From: Dailey, Daniel (DEQ)
To: "Crook, Marty (MD)"
Cc: Taylor, Al (DEQ)
Subject: RE: Well replacement notification
Date: Monday, October 17, 2016 11:05:00 AM

From: Crook, Marty (MD) [mailto:MDCrook@dow.com]
Sent: Friday, October 07, 2016 3:40 PM
To: Dailey, Daniel (DEQ)
Subject: Well replacement notification

Existing Design Details

Proposed Replacement Design

Figure 11
Facility Shallow
Groundwater Monitoring Locations
The Dow Chemical Company
Midland, Michigan

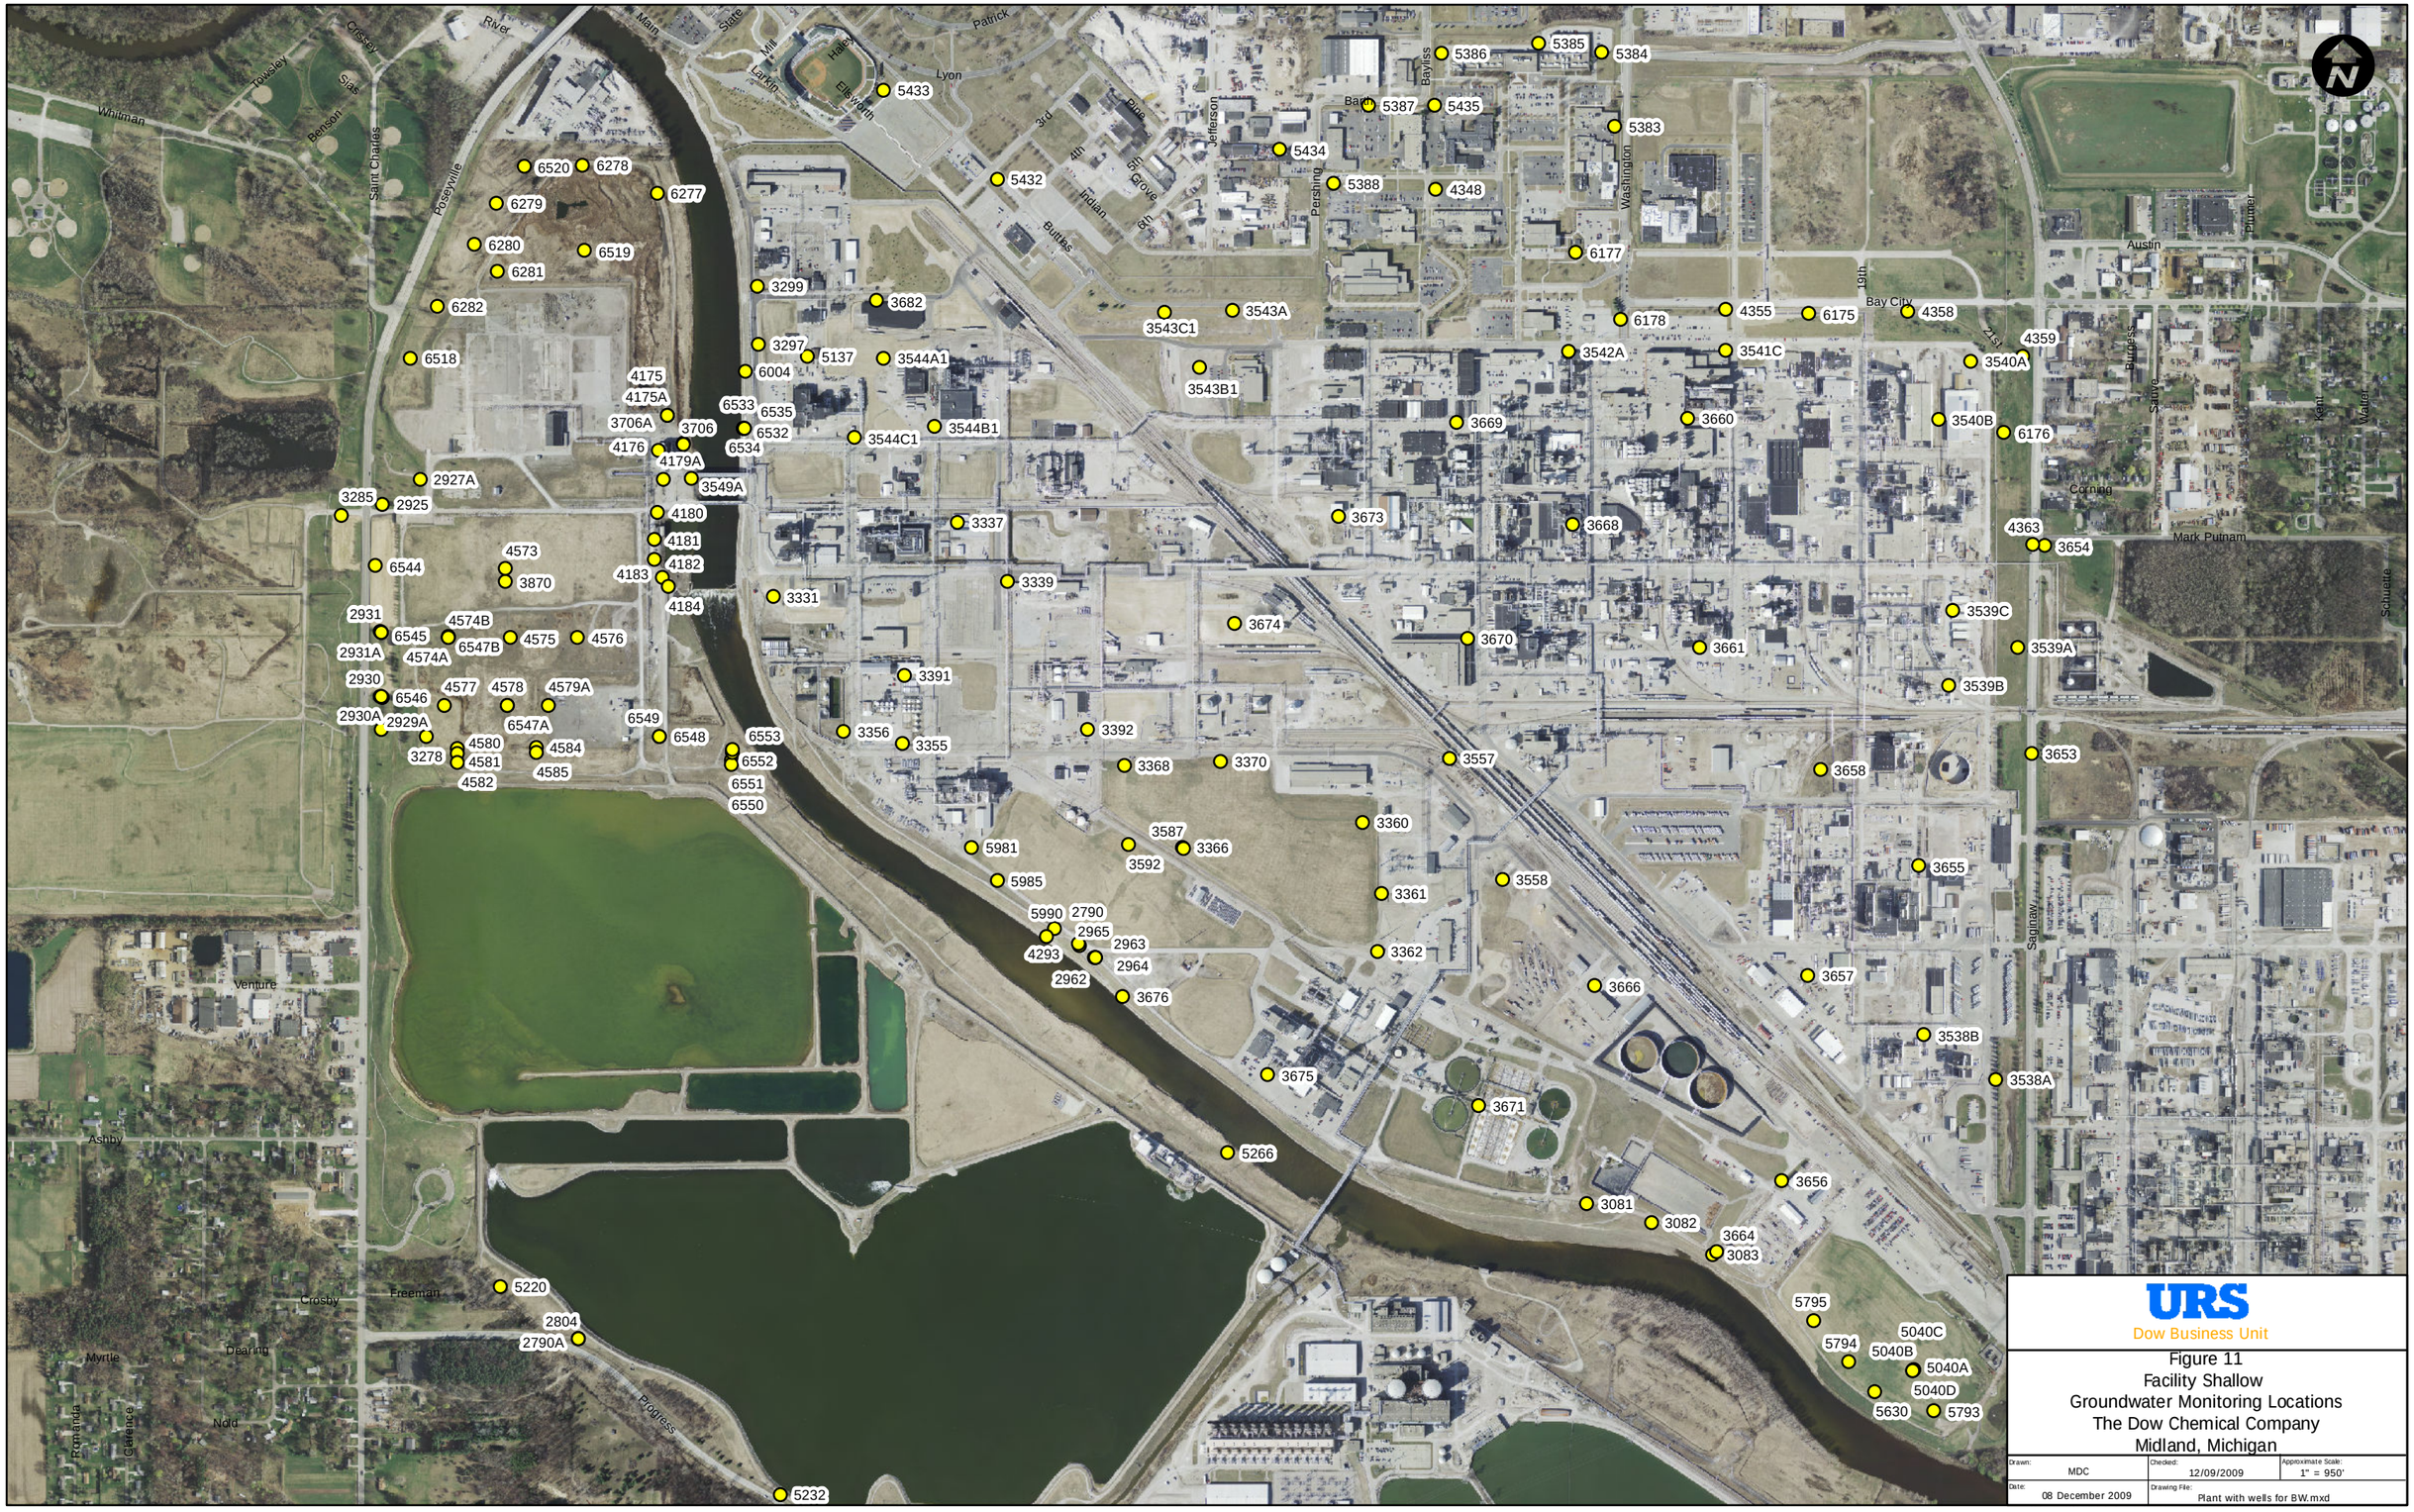
Dan,
There are two wells that I believe I am going to need to replace. Piezometer 3285 and Groundwater Monitoring Well 2908 have damaged protective casings and the well risers are no longer plum. This can results in inaccuracies in the measurement of static water level readings from the wells. In order to correct the issue and repair those damaged protective casings, both of the wells will need to be replaced. Each of the replacement wells will be installed immediately adjacent to the existing wells, and the planned well design details are summarized below. The existing wells will be abandoned consistent with Appendix K of the SAP, Attachment 15 of the license.

Piezometer 3285

- Facility Shallow Hydraulic Monitoring Program Piezometer
- Shown in Figure 11 from SAP
- Depth = 20’7”
- Screen Interval = 17’7” – 20’7”

- Screen Material = 1 ¼” diameter stainless steel No. 10 slot screen
- Riser Material = 1 ¼” diameter schedule 80 PVC

Piezometer 3285 Replacement

- Depth = 20’7”
- Screen Interval = 17’7” – 20’7”
- Screen Material = 2” diameter stainless steel No. 10 slot screen
- Riser Material = 2” diameter schedule 40 PVC

I checked with Al regarding the replacements and they are acceptable. Replacement of the wells is a minor license modification that does not require the prior approval of the MDEQ. Please send me a notification and pictures once the replacements are complete. Based on our review of this notification, Dow remains in compliance with the groundwater monitoring conditions of its operating license. I will update the license web page with this modification as Amendment 6.
